DART SERVICE INSTRUCTION

TO AMEND INSTALLATION INSTRUCTIONS D350-591 REV. G OR EARLIER
AND
INSTRUCTIONS OF CONTINUED AIRWORTHINESS ICA-D350-591 REV. 2 OR EARLIER
REF CANADIAN STC: SH92-6
REF FAA STC: SH967NE

A	NEW ISSUE	RF	09.08.05
REV.	DESCRIPTION	BY	DATE
DESIGN	RF	DART AEROSPACE LTD HAWKESBURY, ONTARIO, CANADA	
DRAWN	RF		
CHECKED	RF	DRAWING NO.	REV. A
MFG. APPR.	N/A	DSI 9472	SHEET 1 OF 2
APPROVED	RF	TITLE	SCALE
DE APPR.	RF	BOLT ADDITION	NTS
DATE	09.08.05	COPYRIGHT © 2009 BY DART AEROSPACE LTD <small>THIS DOCUMENT IS PRIVATE AND CONFIDENTIAL AND IS SUPPLIED ON THE EXPRESS CONDITION THAT IT IS NOT TO BE USED FOR ANY PURPOSE OR COPIED OR COMMUNICATED TO ANY OTHER PERSON WITHOUT WRITTEN PERMISSION FROM DART AEROSPACE LTD.</small>

FIGURE 1: CLAMP DETAIL
OPTIONAL CLAMP CONFIGURATION

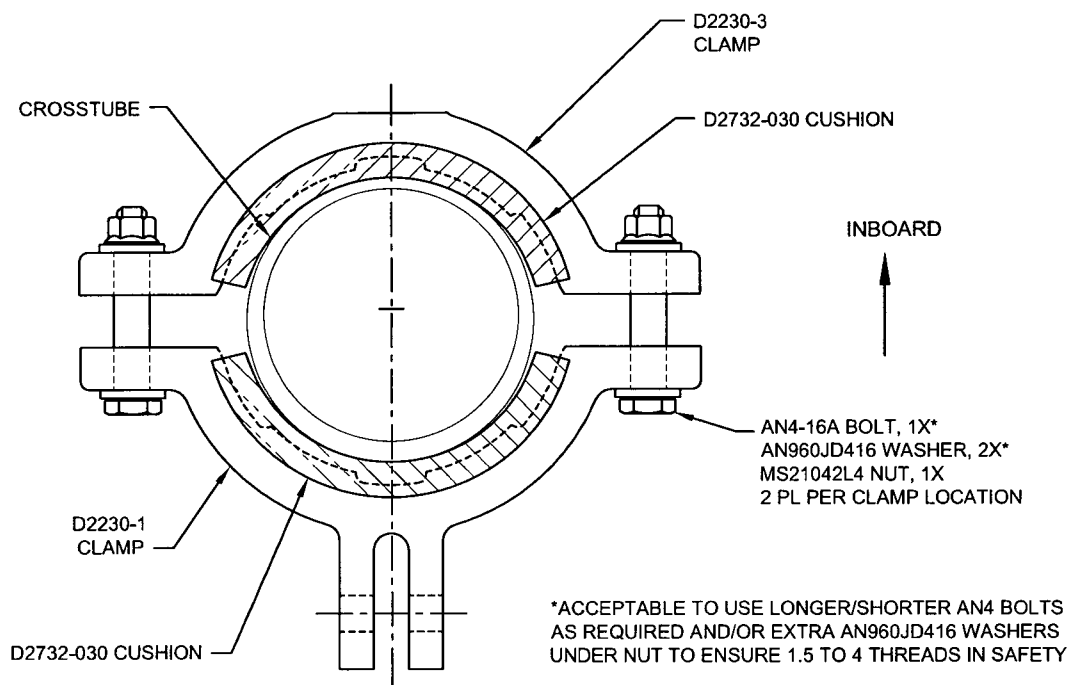
For D350-591-213/-214/-215/-216 steps, customers have the option of installing D2732-030 cushion under the clamps to accommodate varying crosstube diameters and to improve fit, as indicted in Installation Instructions D350-591. This Service Instruction adds longer AN4-16A bolts to the parts list to allow installation of these cushions. See Figure 1 on sheet 2 of this service instruction for reference. Installation of the D2856-400-720 Abrasion Strips per Installation Instructions D350-591 is not required when the cushions are installed.

For D350-591-213/-214/-215/-216 steps at CHG 003, the parts list of D350-591 Rev. G and ICA-D350-591 Rev. 2 is amended as follows:

Qty -213	Qty -214	Qty -215	Qty -216	Part Number	Description
X				D350-591-213	<i>Heli-Access-Step</i> ™, Short Step – High Skid, LH
	X			D350-591-214	<i>Heli-Access-Step</i> ™, Short Step – High Skid, RH
		X		D350-591-215	<i>Heli-Access-Step</i> ™, Short Step – Low Skid, LH
			X	D350-591-216	<i>Heli-Access-Step</i> ™, Short Step – Low Skid, RH
4	4	4	4	AN4-16A	BOLT
